Re: Waterloo Metro Quarter – Southern Precinct – City of Sydney Council Waste Responses

The purpose of this letter is to address City of Sydney Councils *Response to RtS – Waterloo OSD Southern Precinct* – as per the below:

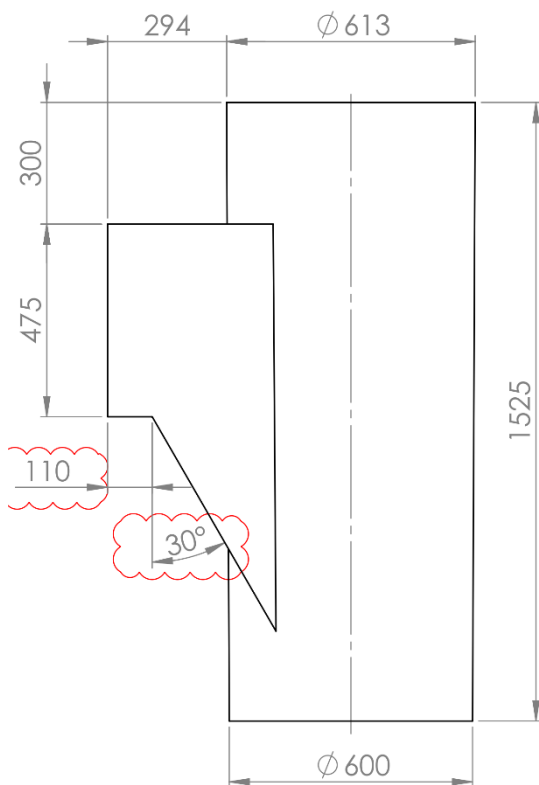
City of Sydney Response	Elephants Foot Recycling Solutions (EFRS) Response
<p>46. a) The application has been amended to reduce the size of the bin rooms and incorporate garbage chutes. A chute room is required on each habitable floor of a development that has a chute system. The chute room must be accessible, not adjacent to a habitable area and be able to accommodate at least 2 x 240L bins for waste and recycling in case of chute failure.</p>	<p>Bin rooms were redesigned during design development with the consultant team to incorporate more functional access through loading dock to bin rooms and each lobby. EFWC engineers were engaged to design the function of the chutes with appropriate equipment to handle the waste into the bins.</p> <p>Chutes were always intended for the site and were located in the same area, the bin handling systems were added after recommendation from EFWC, to be able to manage the volume produced daily.</p> <p>Building 3</p> <p>Due to spatial constraints on the floor plates backup bins have not been designed in to the habitable areas, all chutes are installed behind closed doors creating an air lock and separation from foyer and chute intake doors. An alternative system incorporating a larger chute diameter (reducing the risk of blockage). The system also has an automated blockage alarm reporting to the management office to alert blockage, this system is designed to send an alert with in 5 consecutive failed drops. Thus, allowing building management to release the blockage within 15 minutes.</p> <p>This solution is appropriate given Building 3 is managed full time by staff. The solution has been installed and operating successfully on other projects in City of Sydney</p> <p>See drawing below.</p> <p>Building 4</p> <p>Building meets the City of Sydney’s requirements. The chutes are in an airlock adjacent to the lift lobby and 2 x 240L bins for waste and recycling located in room in close proximity.</p>

Enhanced design reduce the impact area from 45 degrees to 30degrees

Increase chute diameter to 650mm

Both these elements will reduce blockage possibility, with an electric warning systems also installed any blockage will trigger an alarm to the building management team with in 15min.
